TO: DEVELOPMENT REVIEW BOARD **DATE:** FEBRUARY 21, 2002
FROM: COMMUNITY DEVELOPMENT
SUBJECT: CASE 82-DR-1998#2A

REQUEST: Approve site plan & elevations for Phase 2 of the Promenade
PROJECT NAME: The Promenade - Phase 2
LOCATION: Southeast corner Scottsdale Rd. & Frank Lloyd Wright Blvd.

ELEVATIONS
SCREENWALLS

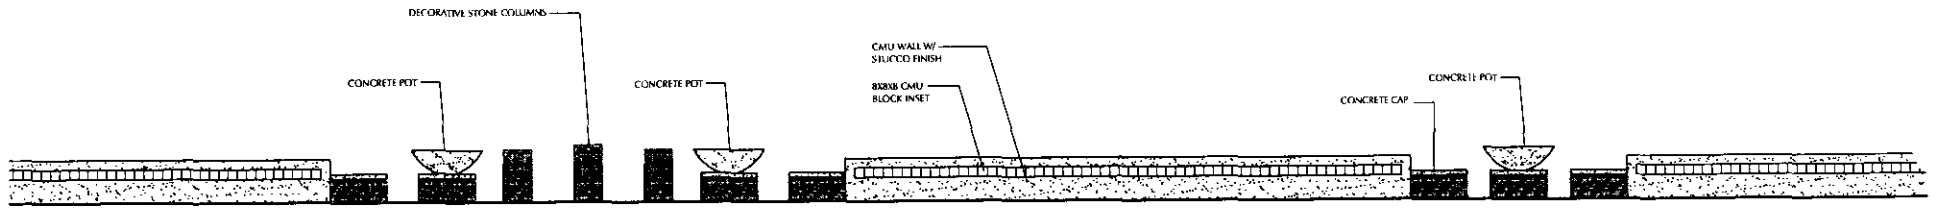
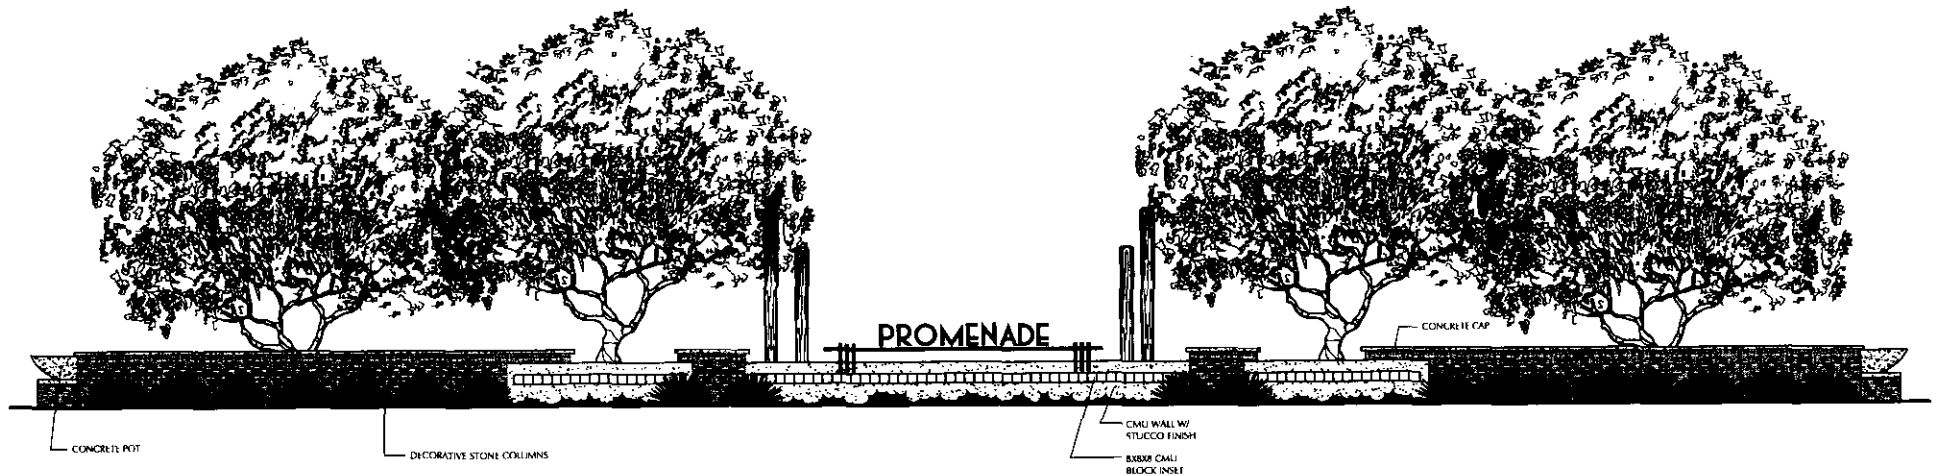
2) At the corner of Scottsdale Road and Frank Lloyd Wright Boulevard, the applicant shall integrate into the site wall & planter details the City of Scottsdale's Entry Monument. The Monument component shall meet the intent of the City of Scottsdale design standards for entry monuments and be oriented so that it is viewed by east bound (FLW Blvd.) traffic crossing the Scottsdale Road intersection. Components of the surrounding design features shall also integrate into vertical surfaces, adjacent to the entry monument, repetitive Frank Lloyd Wright Boulevard Streetscape Design Guideline symbols in a manner that respects the design guidelines. The applicant shall submit plans for Staff approval.
